ADDENDUM NO. 1

Date Issued: August 11, 2021

RE: LINDEN ROSELLE SEWERAGE AUTHORITY
Contract Number 61-19
Emergency Generator Switchgear Replacement

PROJECT NO. 5015-239030
 FILE NAME: E006STUG.DWG
 SHEET NO. E-6
 ISSUED FOR BID

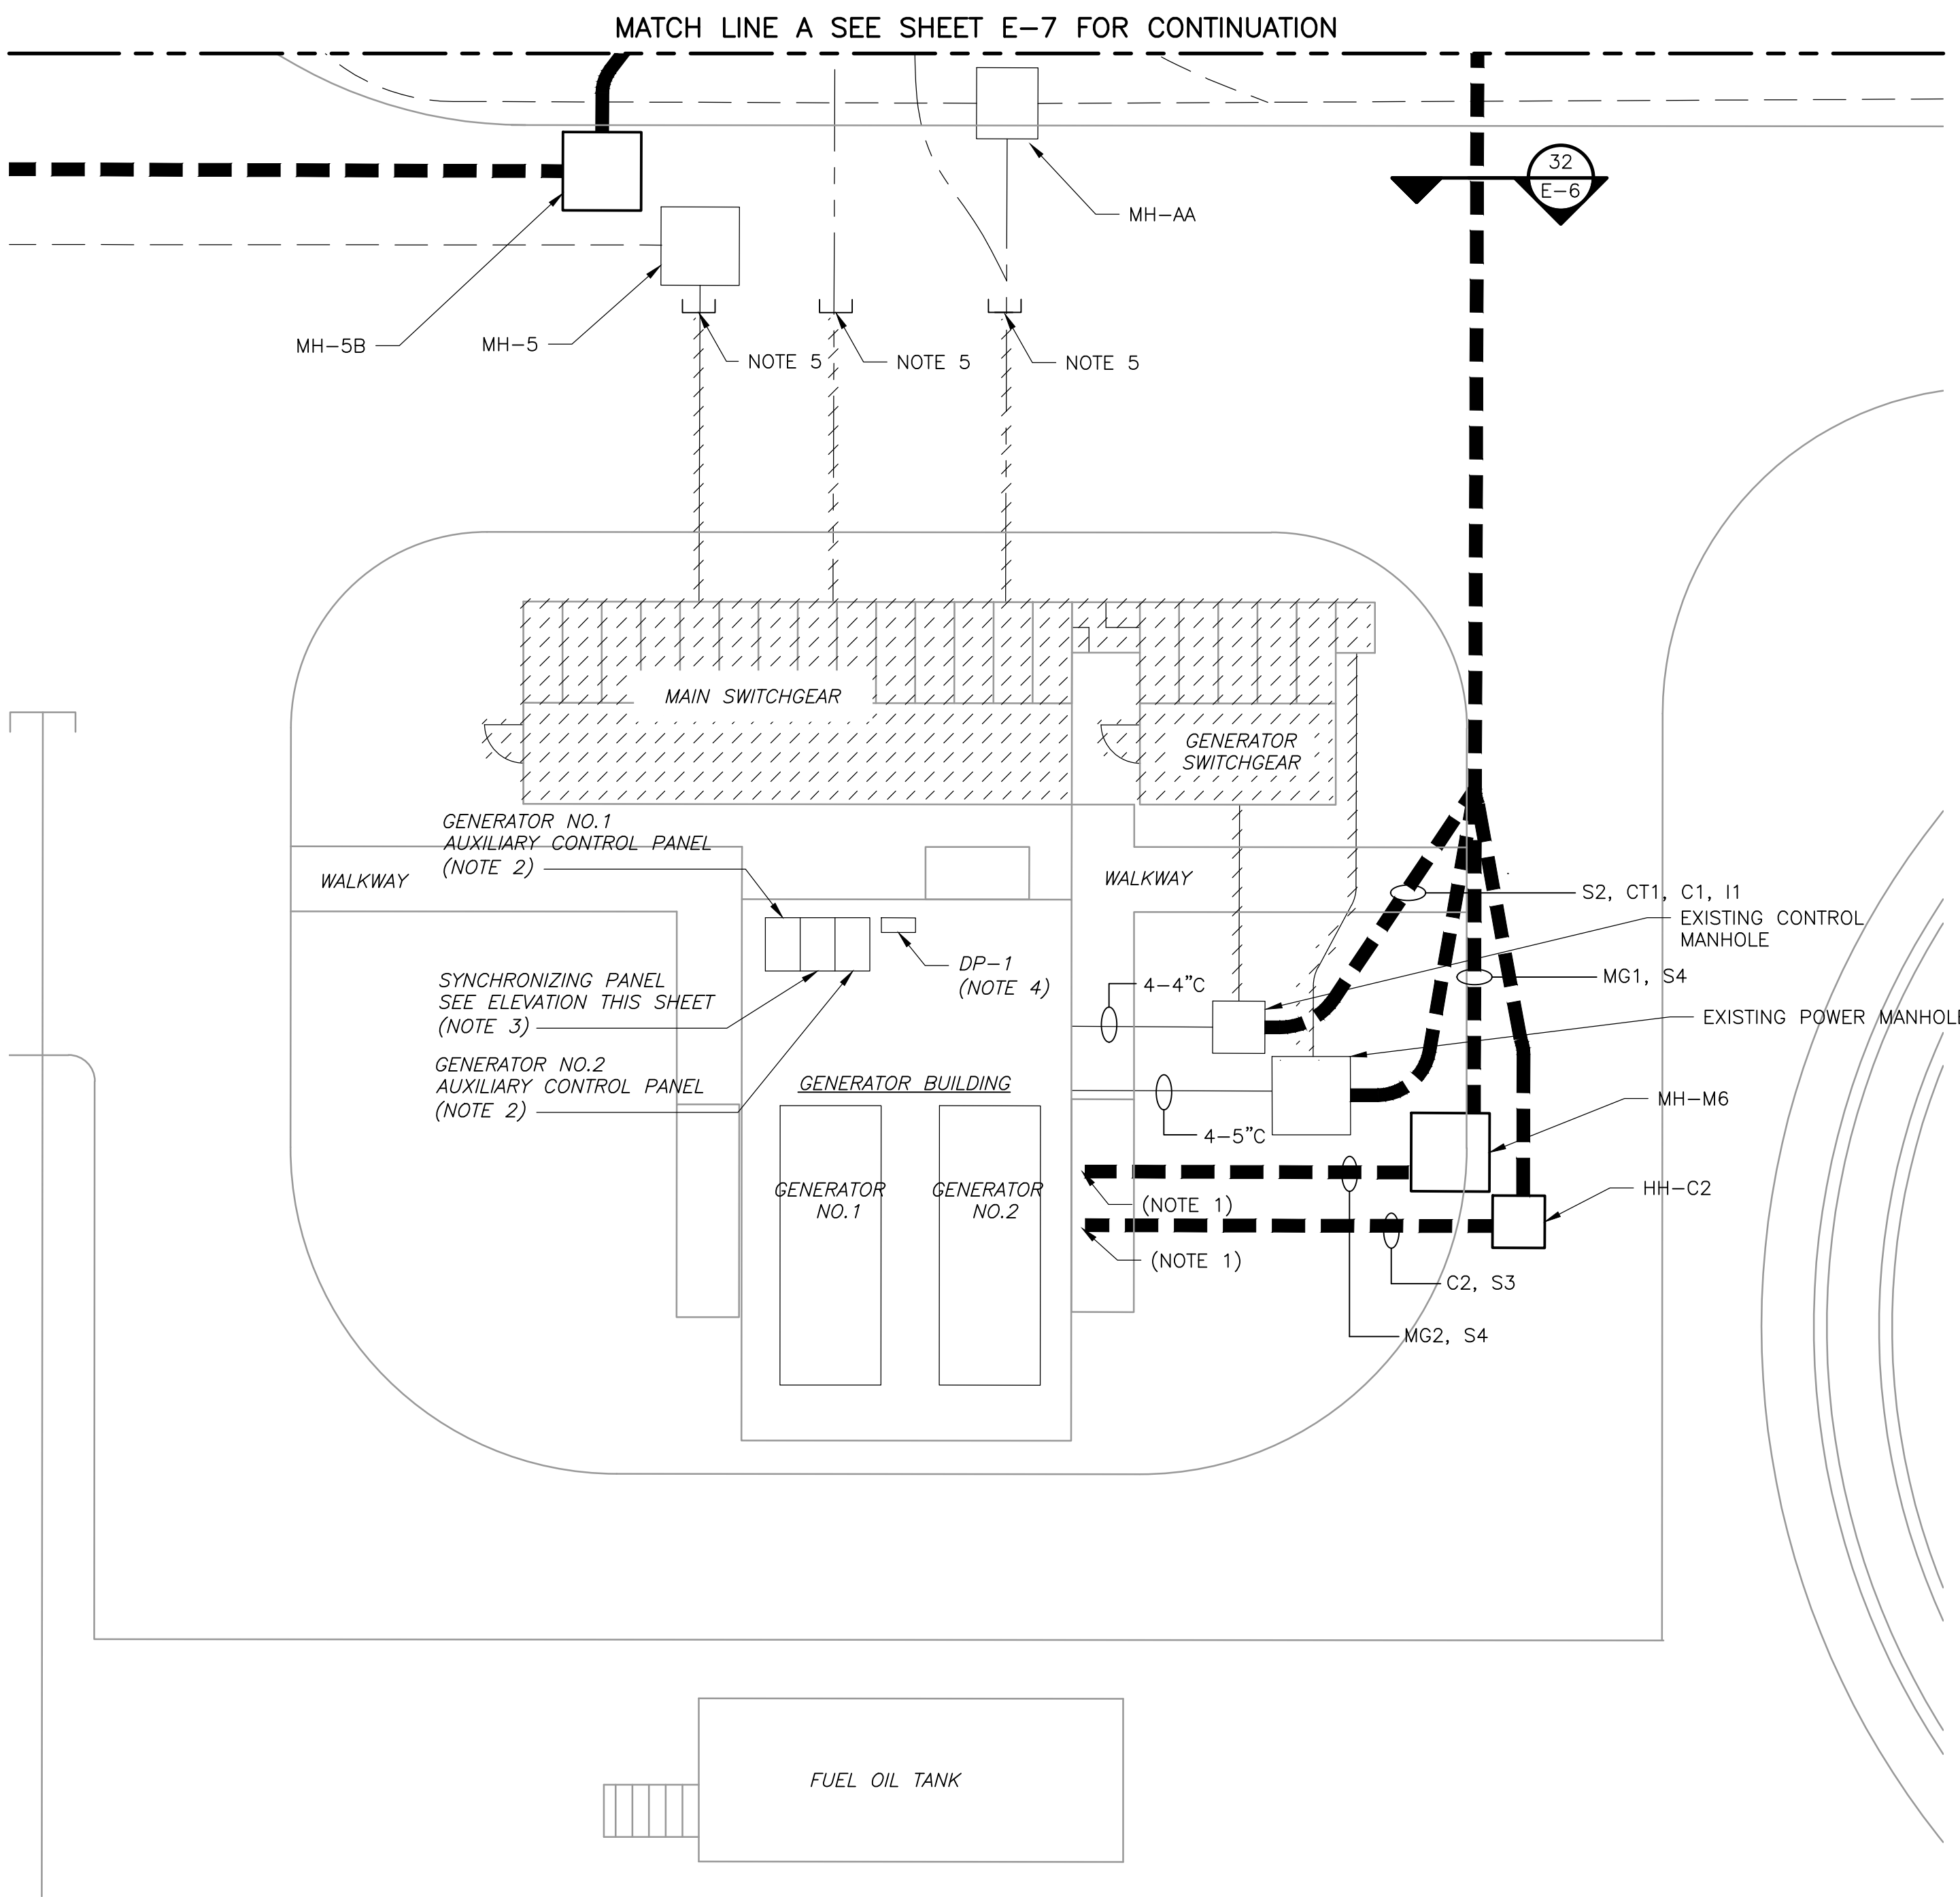
8. QUESTION/COMMENT: Drawing E-6 Note #1 says to see sheet E-5 for underground raceway schedule. E-5 schedule is missing information many of the conduits called for on E-6. The schedule on E-14 seems more complete. Which is to be used?

RESPONSE: See Addenda Item #5. Drawing E-6 has been revised.

NOTES:
 1. SEE E-14 FOR CONDUIT AND WIRING REQUIREMENTS AND RISER DIAGRAM FOR CONNECTION OF EQUIPMENT FOR CONDUIT TAGS SHOWN ON THIS SHEET.

PROJECT NO. 5015-239030
 FILE NAME: EO08STPL.DWG
 SHEET NO.
E-8

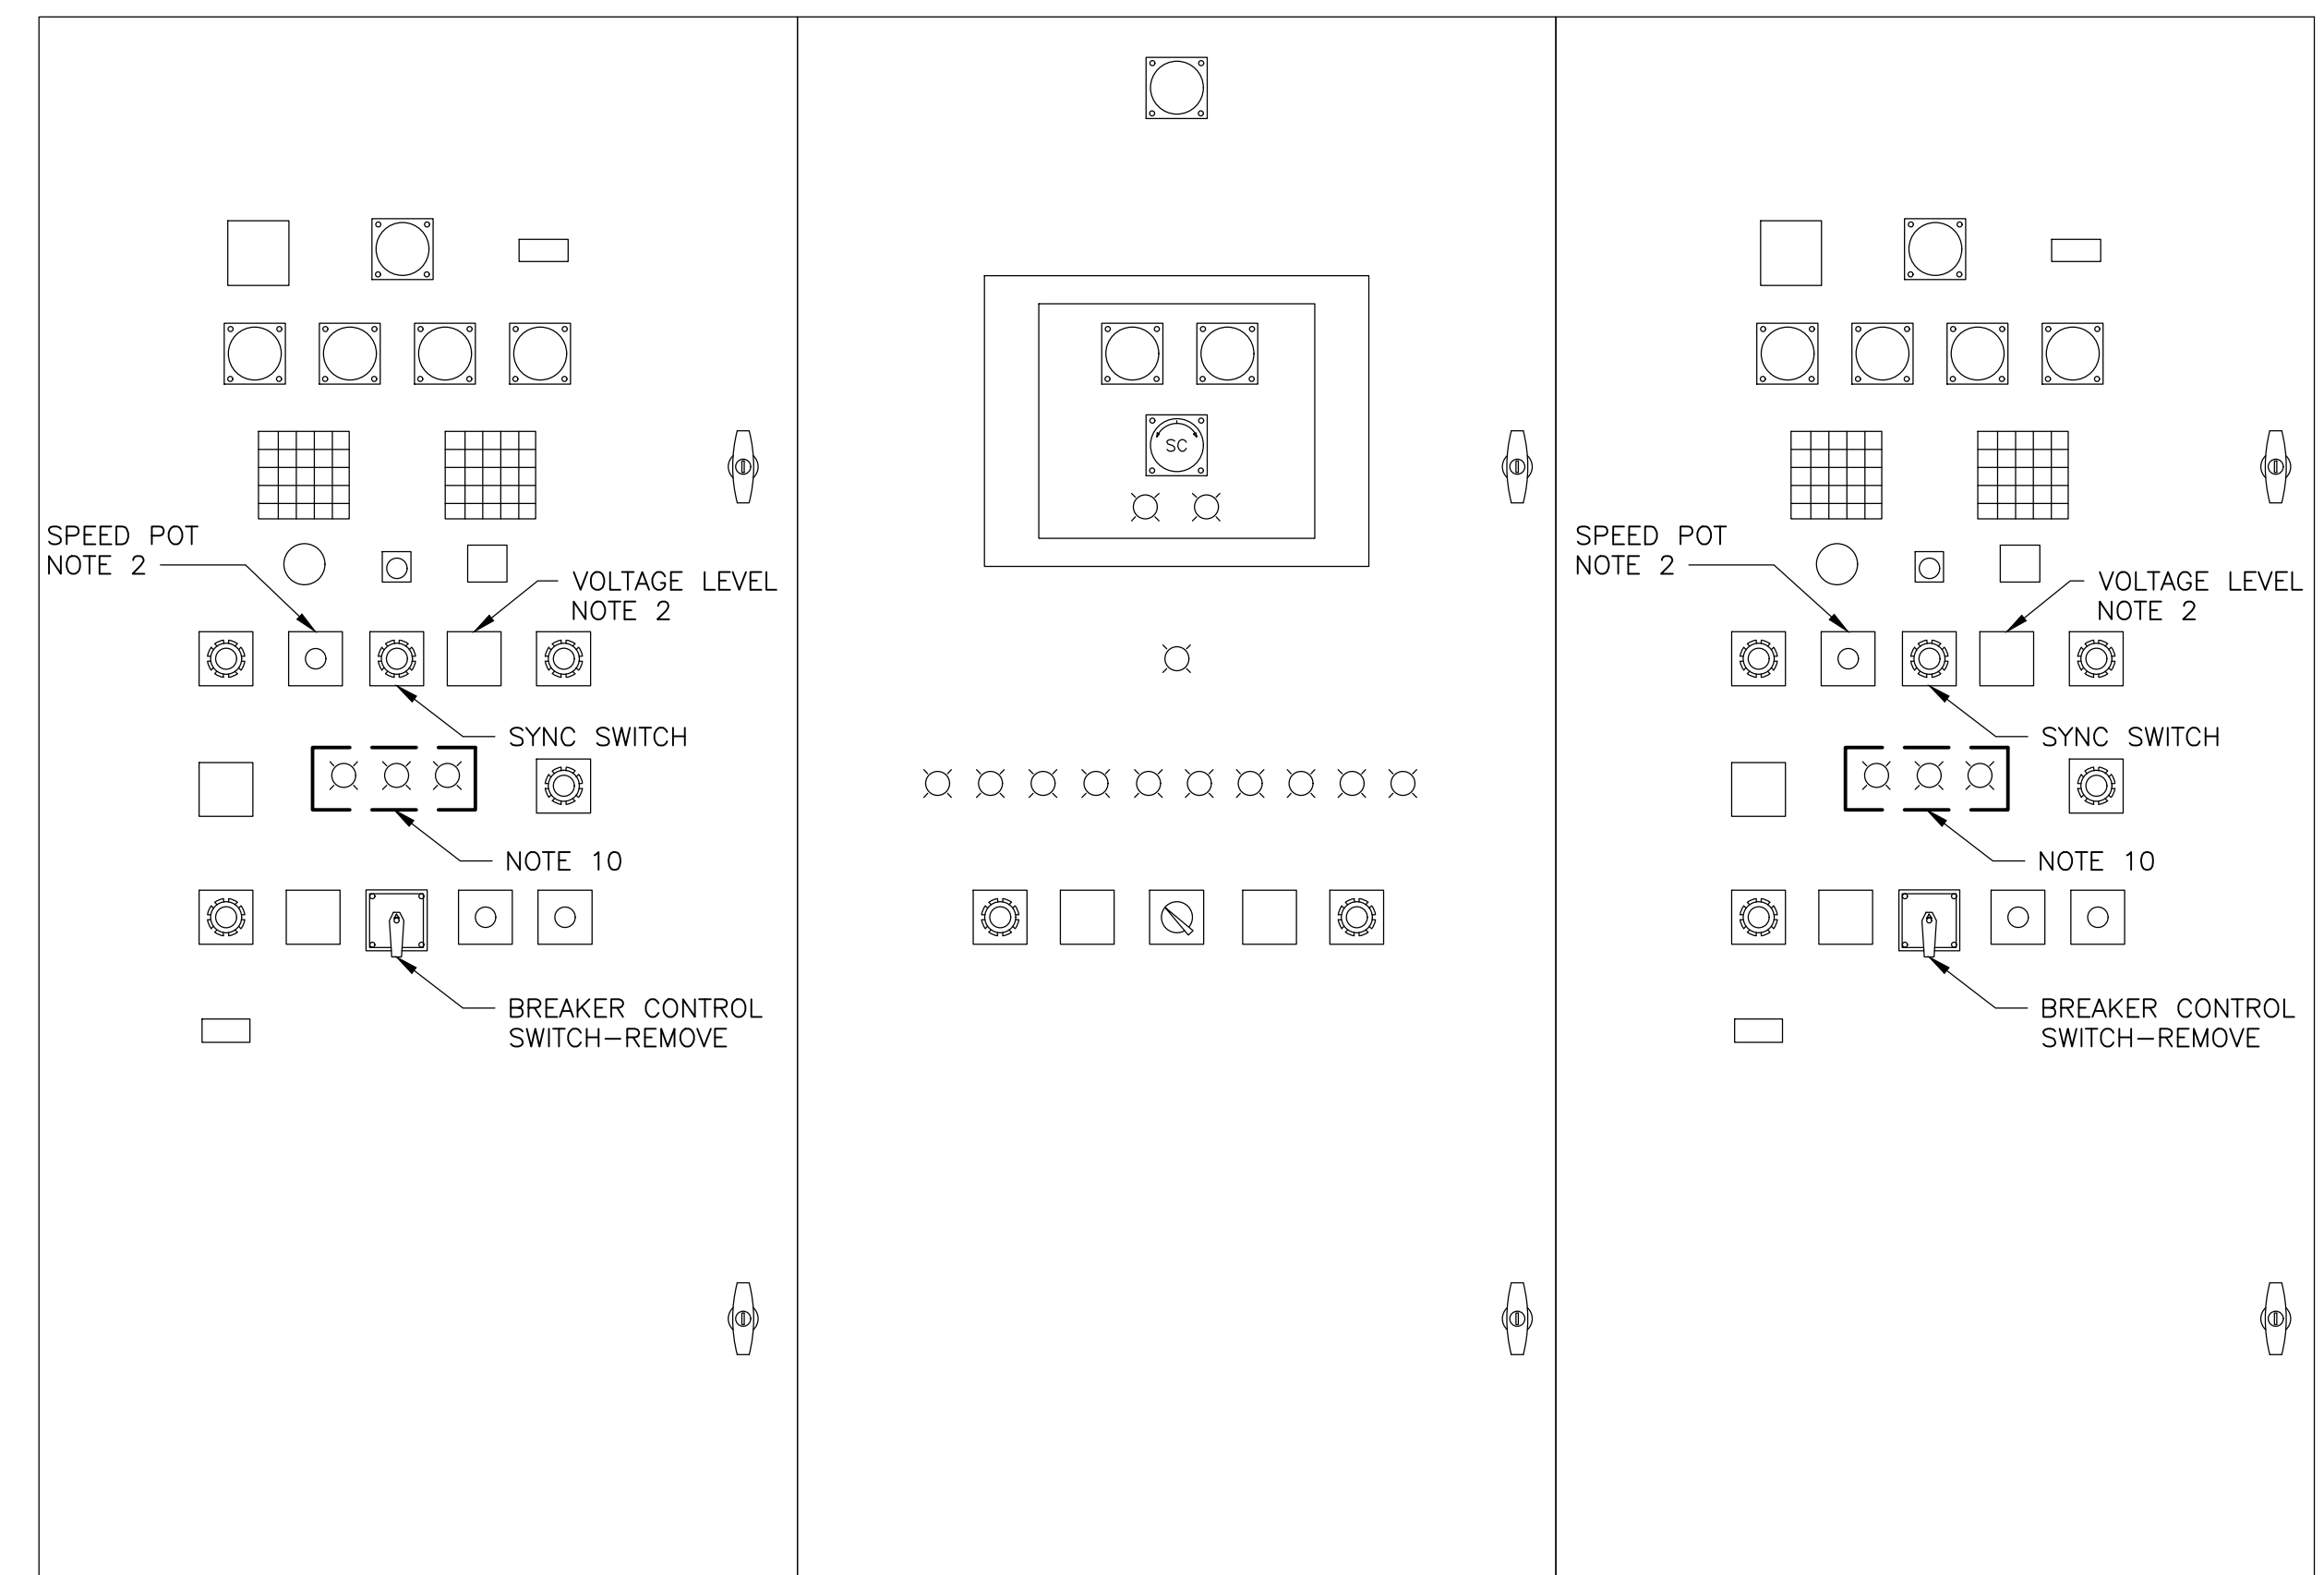
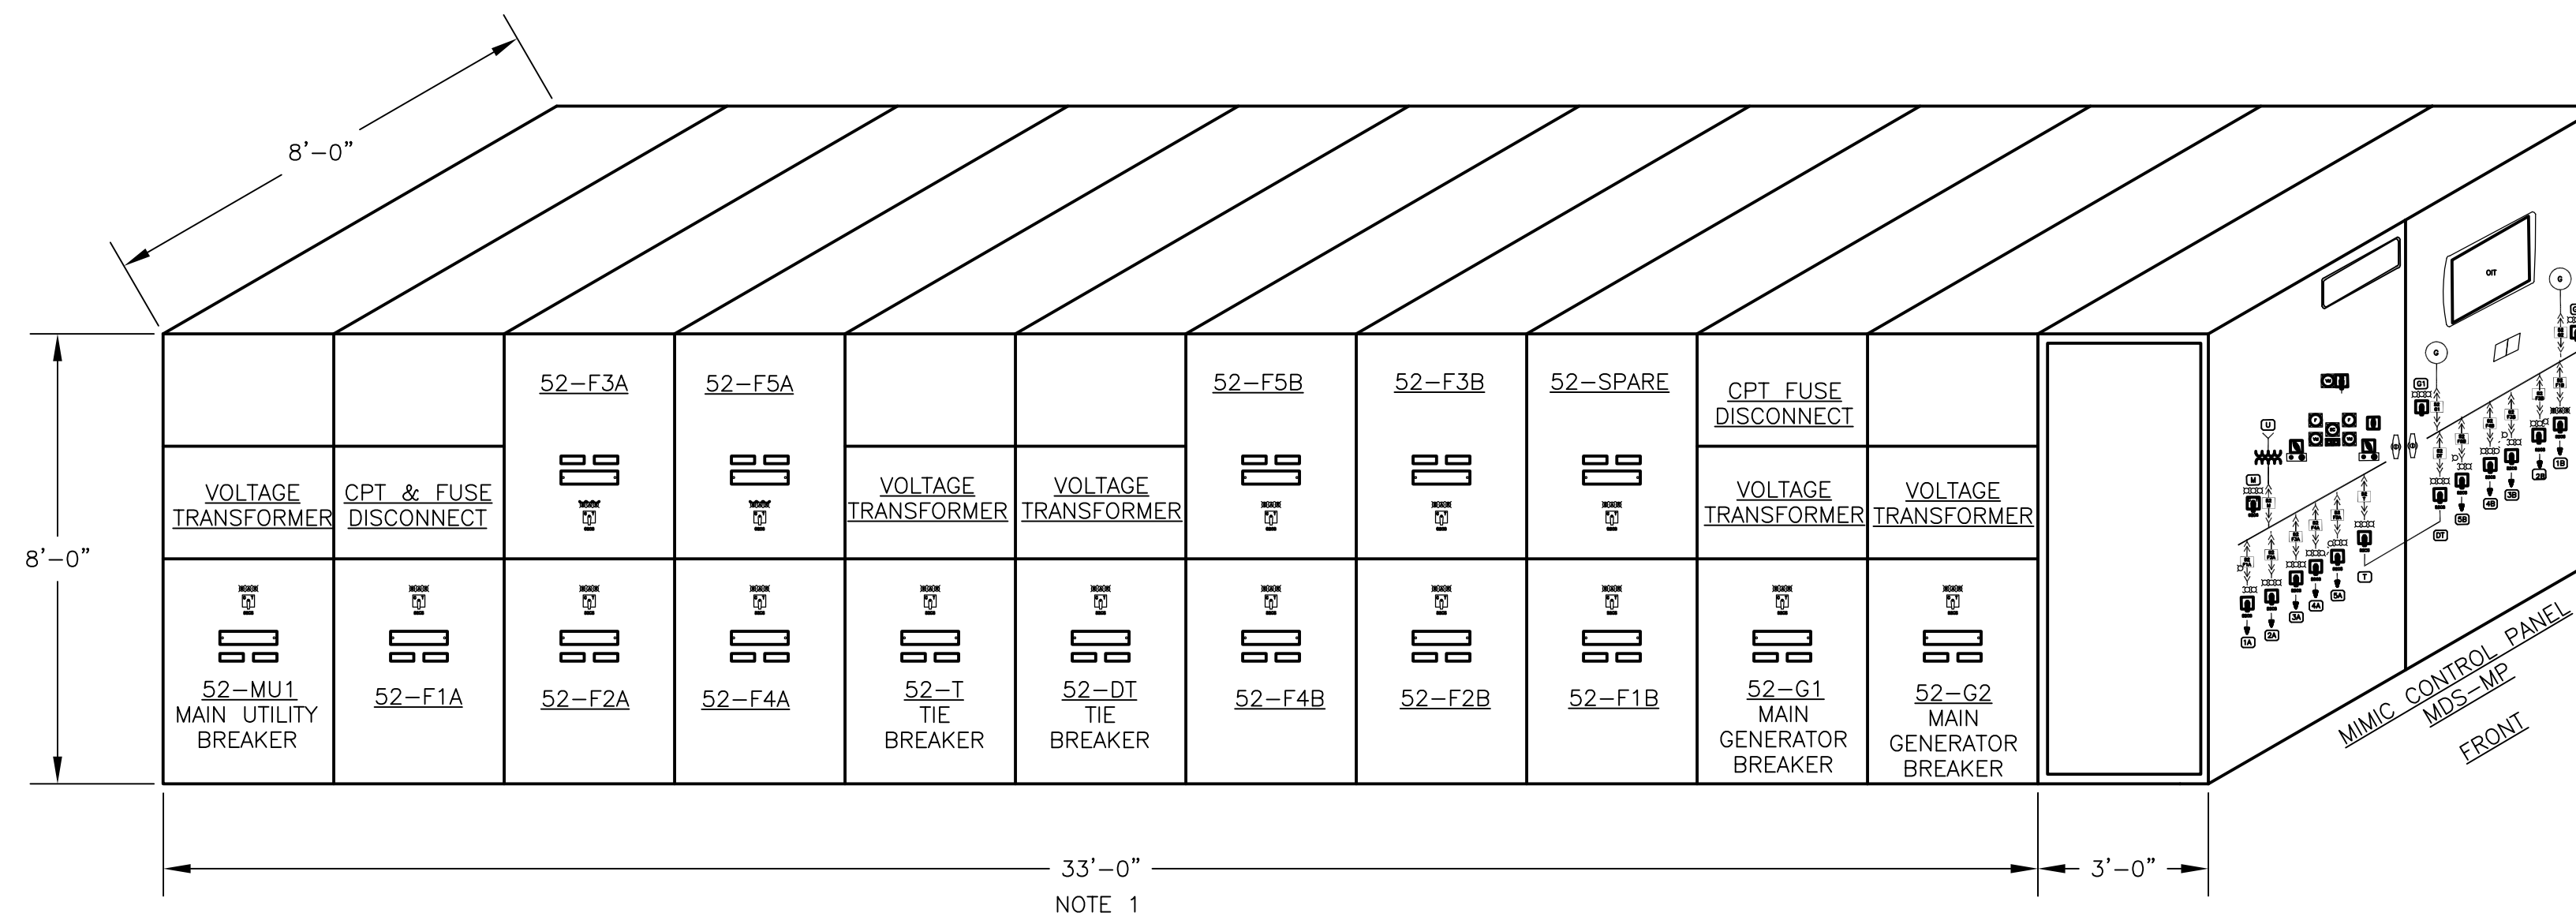
3. QUESTION/COMMENT: Please provide correct scale on drawing E-8.

RESPONSE: See Addenda Item #3. Drawing E-8 has been updated.
